ADDENDUM No. 4

RFP No. 24-08

S Seventh St. & Greenview Dr. Improvements

00	2/21/24	ENG	CEC
REV. NO.	DATE	DRAWN BY	CHECKED BY
STANDARD STORM MANHOLE (SEPARATE BASE)			
DR. ENG	CH. ENG	DRAWING NO.	
SCALE N.T.S.	DATE 12/8/2023	SD-ST-1A

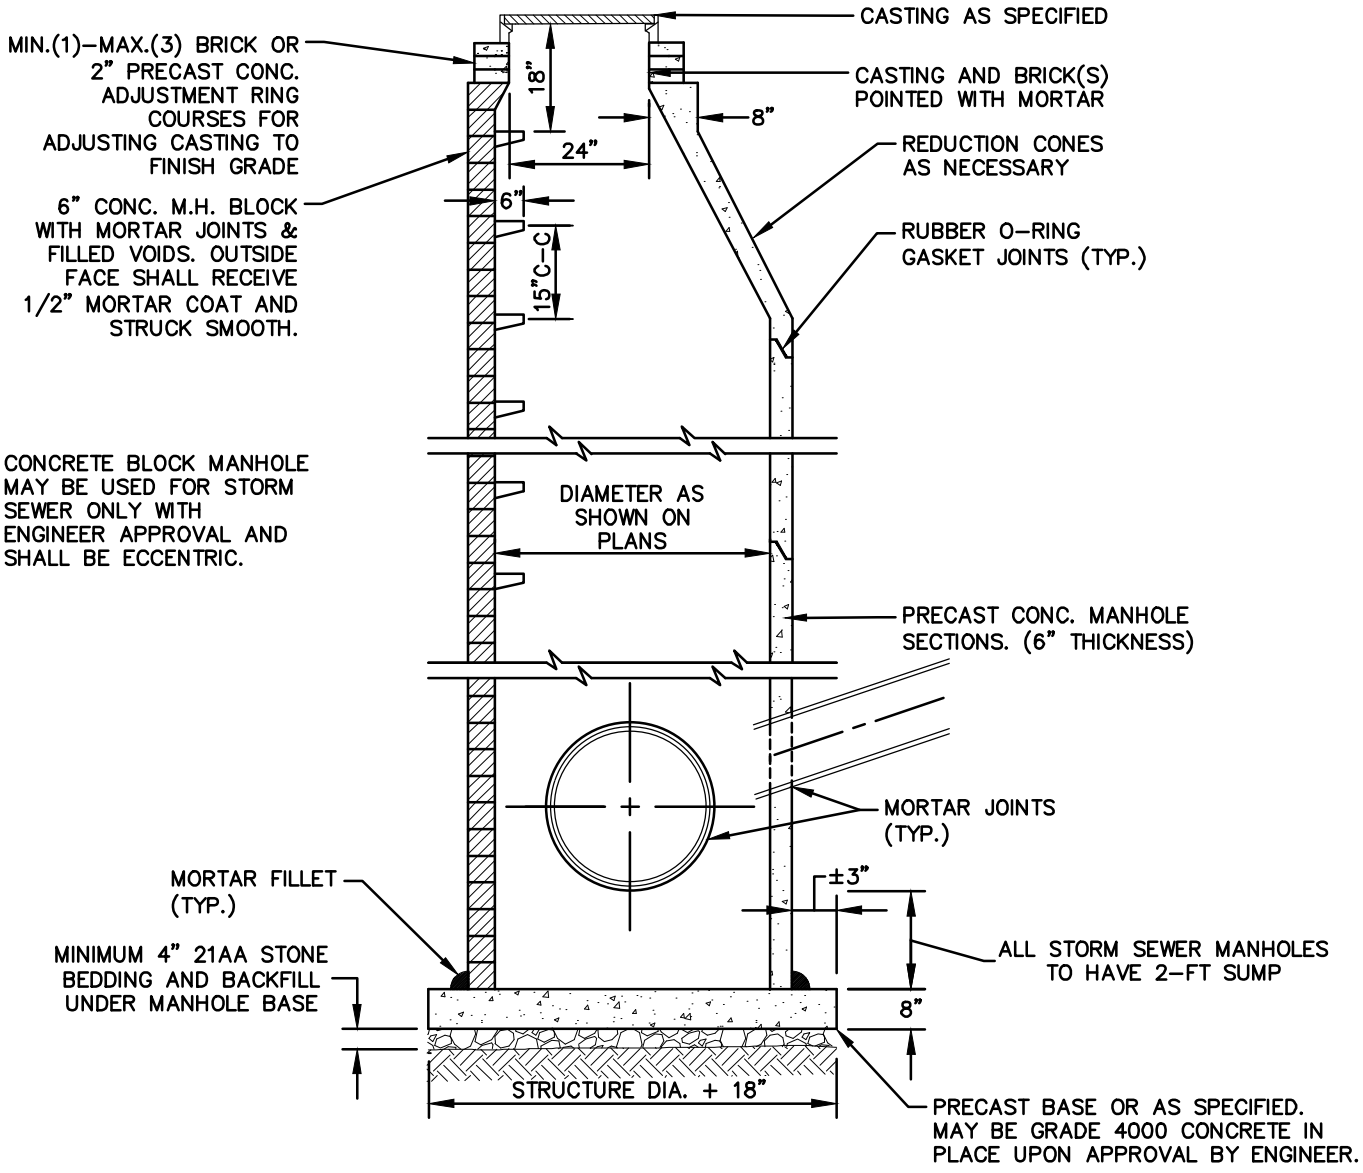
Replace SD-ST-1A	Rubber boot connections and testing sleeve removed.
---------------------	---

Comment: The intent of Addendum 4 is to include SD-ST-1A that was omitted in Addendum 3.
